# NEBRASKA CAPITOL ENVIRONS COMMISSION

2. *Downtown Corridors Streetscape Project (Planning and Urban Development Departments, UDR24101)*

## NEBRASKA CAPITOL ENVIRONS COMMISSION STAFF REPORT

APPLICATION NUMBER	Urban Design Record #24101
APPLICATION TYPE	Certificate of Appropriateness
ADDRESS/LOCATION	Downtown Corridors Streetscape Project
HEARING DATE	July 26, 2024
ADDITIONAL MEETINGS	-
APPLICANT	Hallie Salem (Urban Development), 402-441-7866, <a href="mailto:hsalem@lincoln.ne.gov">hsalem@lincoln.ne.gov</a>
STAFF CONTACT	Collin Christopher, 402-441-6370, <a href="mailto:cchristopher@lincoln.ne.gov">cchristopher@lincoln.ne.gov</a>

## ATTACHMENT B – Site Plan

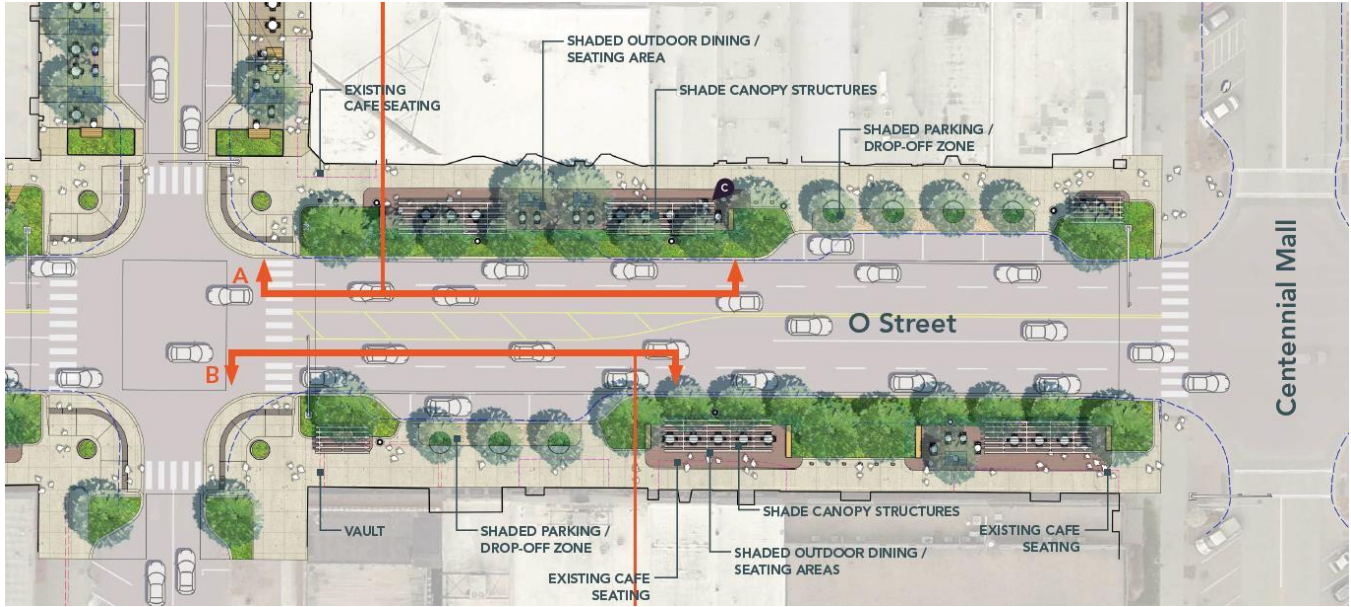
**Recommended finding:** The planned Downtown Corridors streetscape improvements within the Capitol Environs District (O Street between 14<sup>th</sup> and Centennial Mall) generally comply with the Capitol Environs Design Standards.

**Recommended action:** Approval of a Certificate of Appropriateness for the planned Downtown Corridors streetscape improvements within the Capitol Environs District (O Street between 14<sup>th</sup> and Centennial Mall).
